Planning Scheme Amendment C280
32-68 Mollison St, Abbotsford

Expert Evidence - Urban Design
Leanne Hodyl

**32-68 Mollison Street, Abbotsford
Urban Design Peer Review**

Prepared for the Yarra City Council
October 2019

Figure 1 Incorporated Plan Overlay (C170).

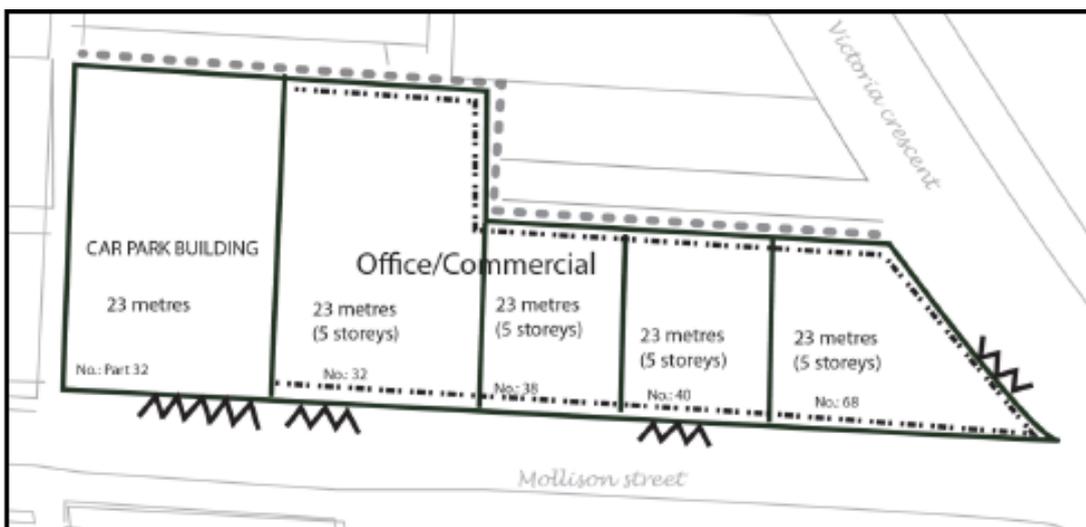
- 3) The purpose of the Incorporated Plan Overlay (see Figure 1) was to facilitate the use and development of the land at 32-68 Mollison Street for office, commercial and other compatible uses.

- 4) The Incorporated Plan Overlay included the following key provisions -
 - » A mandatory maximum height of 23 metres (5 storeys), the management of the northern interface to provide for continued industrial purposes, a building setback above the parapet of 2m, and a preferred vehicle entry/exit identified on Mollison Street and Victoria Crescent.

Figure 3 Approved permit at 12-20 Victoria Crescent (with key factors noted).

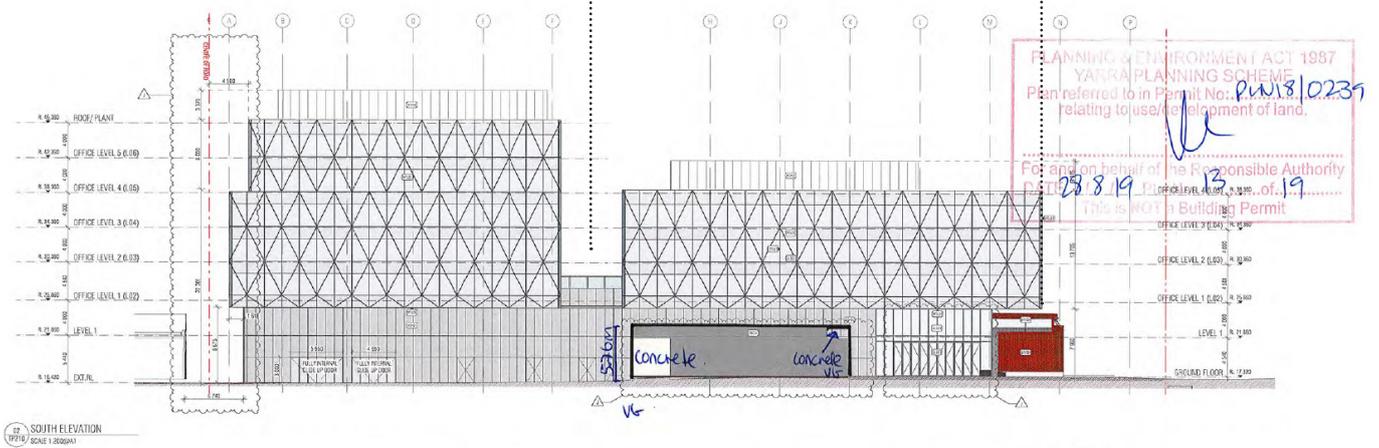
- 18) The approved development at 12-20 Victoria Crescent includes the retention of a portion of a heritage building, a high-level of activation to Victoria Crescent and a break in the massing at the second level to create two distinct upper level forms of varying heights (see Figure 3).

- 50) The subject site is more comparable in size (4,360m²) to the site to the north (approximately 4,100m²).
- 51) The site to the north provides a distinct break in the massing above a two storey podium. The separation between these upper level forms is approximately 7.5 metres (see Figure 3).

Figure 6 Looking north-west along William Street towards the subject site.

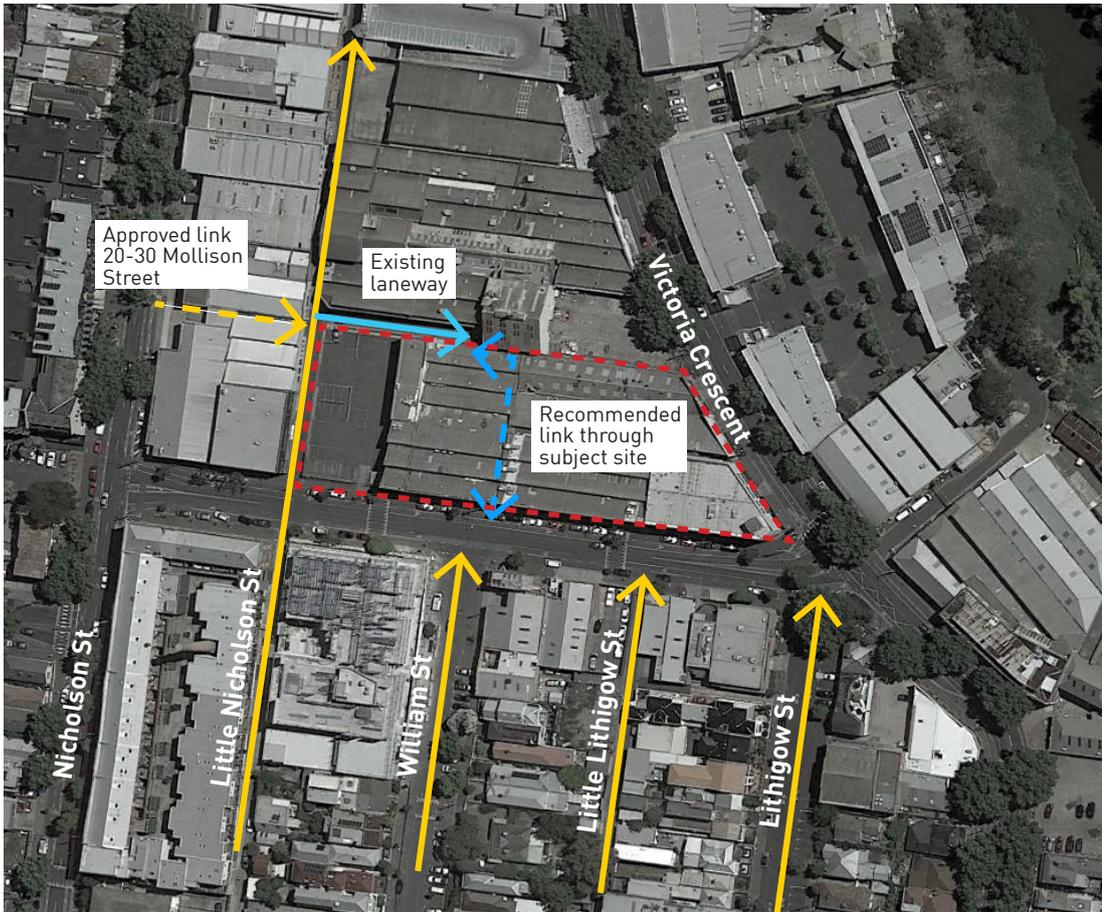
- 27) There is an opportunity to extend William Street to the north which would offer the following benefits within the subject site:
 - » Reducing visual bulk at the Mollison Street frontage by breaking up the overall massing, particularly as its viewed from the low-scale residential dwellings on William Street.

- » Providing an opportunity to reduce traffic impacts on Little Nicholson Street by locating the carpark entrance off a new service laneway.
 - » Improving amenity at the lower levels of the building by increasing outlook.

- » Connecting to the existing laneway to the north of the site and effectively expanding the pedestrian network in line with the proposal at 20-30 Mollison Street in which an east-west pedestrian link has been provided at the northern interface.

- Provide a pedestrian link that connects William Street to the existing laneway to the north of the site (nominally 6m in width).
- Vehicle access to the subject site should occur off a new service laneway within the site.
